Development Permit
Notice of Decision
REVISED – October 11, 2024

Proposed Development: Multi-Attached Dwelling: *85 Apartments and 42 Townhouses*
Amendment: Removal of the underground parking and to be replaced with surface parking, landscaping, and a play area

Legal Description: Plan 202 2084, Block 5, Lot 3
Municipal Address: 4701 32 Avenue, Beaumont, AB
Land Use District: Integrated Neighbourhood
Permit Application No: 2021-338
Tax Roll: 009491

Development Permit Status: Approved with conditions

3 SILO GARBAGE BIN DETAILS
A1.0 N.T.S.

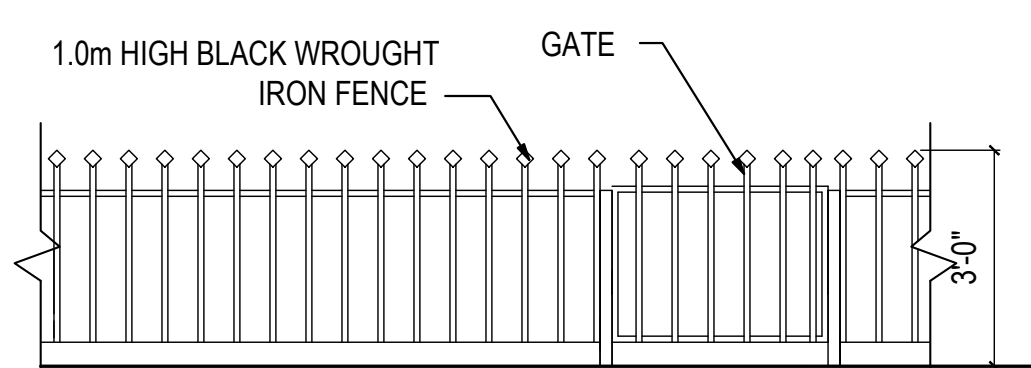
1. All other conditions of Development Permit 2021-338 remain in full force and effect except as otherwise amended herein.
2. The apartment underground parkade has been removed thus providing for 12 surface parking stalls. No variance is required to parking.
3. The landscaping requirements have been revised to accommodate the removal of the underground parkade. The Applicant shall ensure there are 39 trees, 16 of which are coniferous and 23 deciduous as shown on the approved attached plans. No variance is required to landscaping.
4. The lighting locations have been revised to accommodate additional lighting for the surface parking stalls and play area.
5. The design of the solid waste receptors have been revised to provide for molok 2 stream waste diversion. No variance is required to solid waste.
